BULLETIN NO. 19/20-014 DATE: 30 Dec19

TO: ALL ISR Oval / Vintage Oval /Enduro Racing Affiliates

SUBJECT: Ski Hoop/ Ski Tip Turn up Measurement

Photo credit Craig Henning

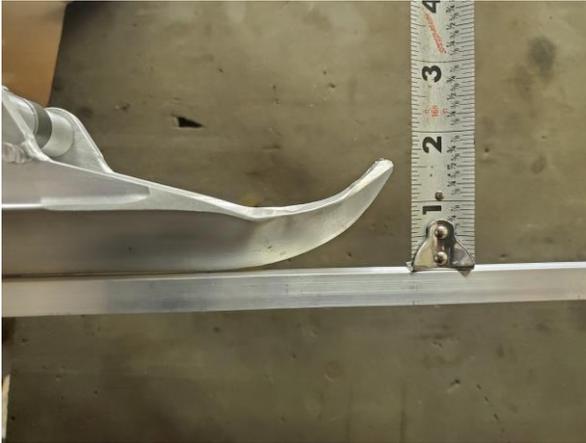
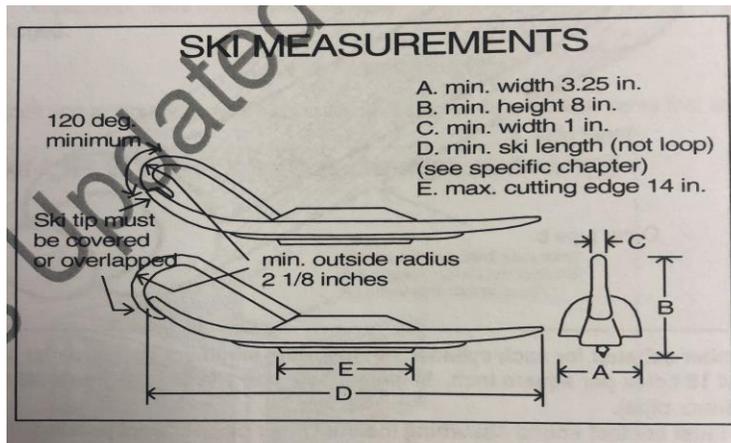
1. Ski tip (not including the loop) must be turned up 1.5 inch from the bottom of the ski.

This measurement is made with NO carbide and host bar installed and ski resting on a sold surface. (Above B)

The real problem are ski's that are designed with no tip up at all, or ski blanks that end square cut, of which if the loop breaks leaves open material ends and no protection.

2. All ski loops must be at least one (1) inch wide and 5/8-inch-thick or 1-inch diameter round material. The arc of the leading edge of the ski loop must have an outside radius of at least 2 1/8 inches and extend at least 120 degrees upward (see illustration). Plastic ski loops must be affixed with steel bolts.
3. Ski tip must be covered or overlapped.

This measurement is made with carbide and host bar installed and ski resting on a sold surface. (Above B) The taping and padding of the ski loop may be included in the measurement.
